TECHNICAL SPECIFICATION CHANGE TO SUPPORT ELIMINATION OF ENGINEERED SAFETY FEATURES ACTUATION SYSTEM SINGLE POINT VULNERABILITY

WATERFORD 3

Pre-Submittal Meeting

1 out of 1 Logic - Simplified View

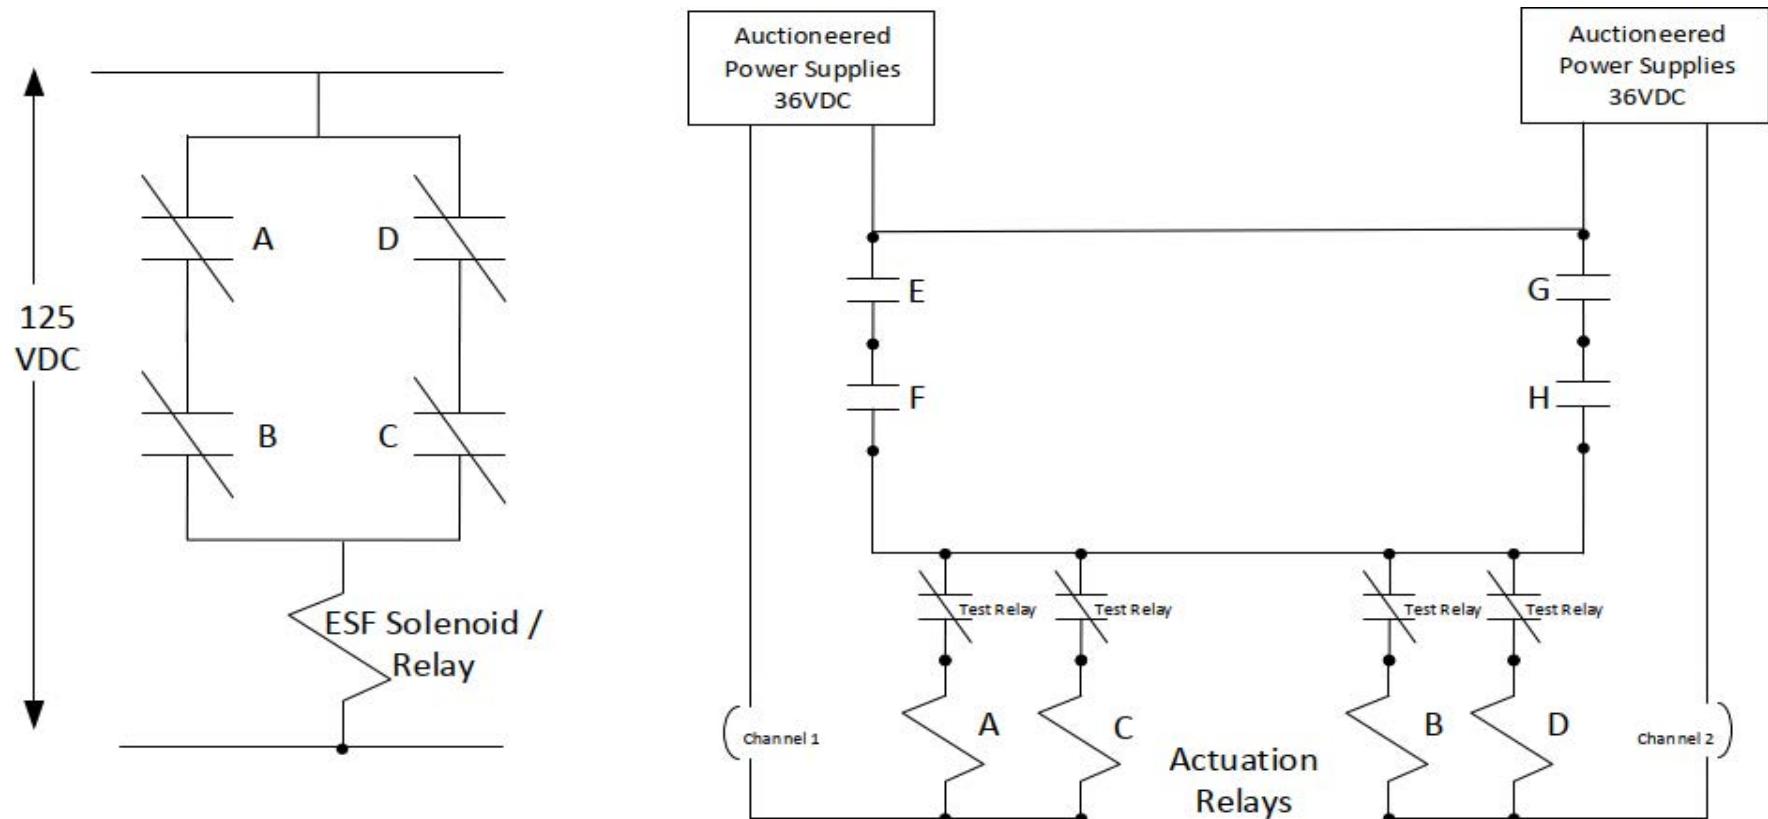
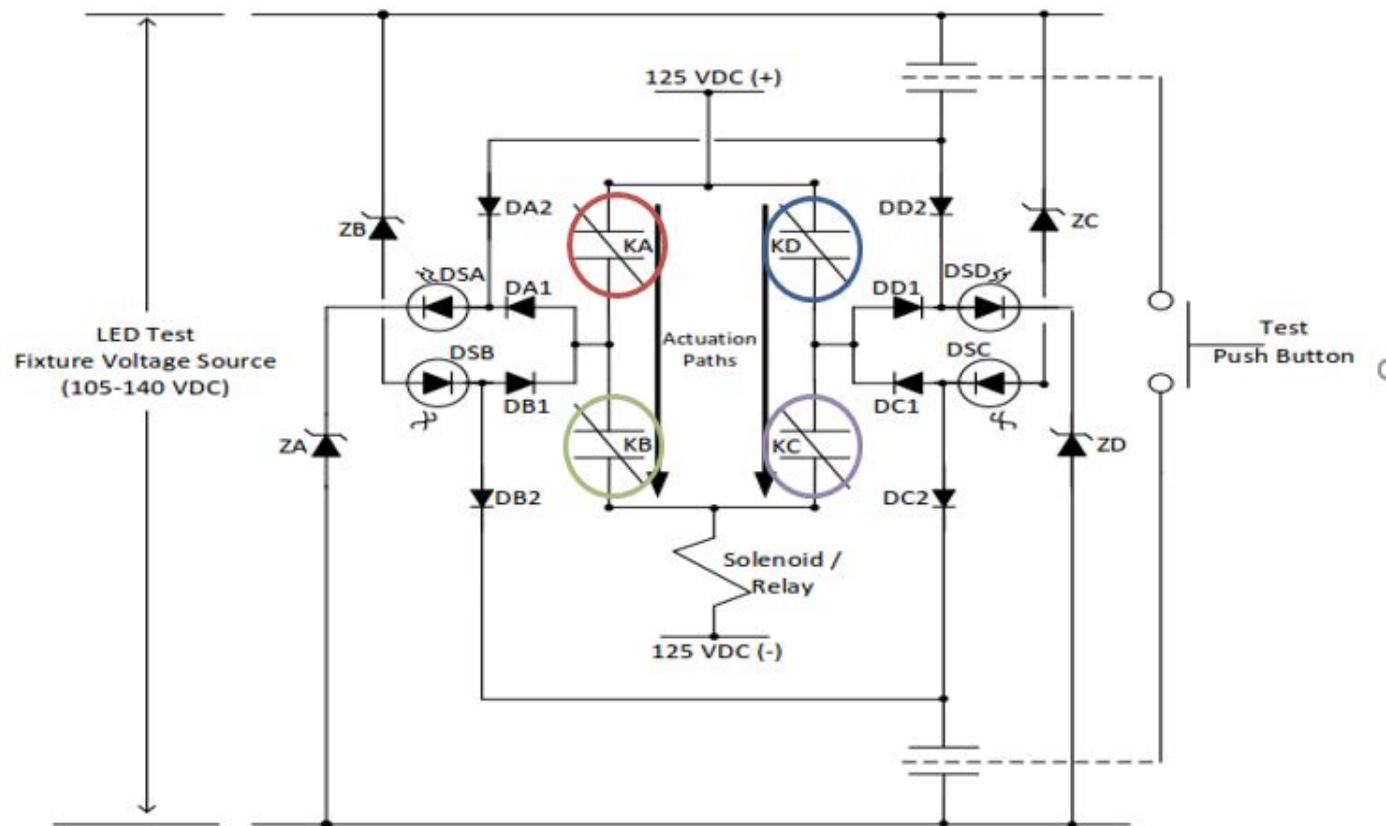
- Revise the ESFAS Actuation Circuit from a 1 out of 1 logic (Slide 14) to a parallel 2 out of 2 logic (Slide 15).
 - Removed the SPV from the circuit
 - Parallel 2 out of 2 logic meets the Reg Guide 1.22 requirements
- Add an LED Test Fixture with an LED to illuminate when an ESFAS Actuation Relay Contact closes.
 - Provides indication of failed relay
 - Provides safe means to test without need for intrusive maintenance using meters for voltage and continuity checks
- Modification will be implemented under 10 CFR 50.59
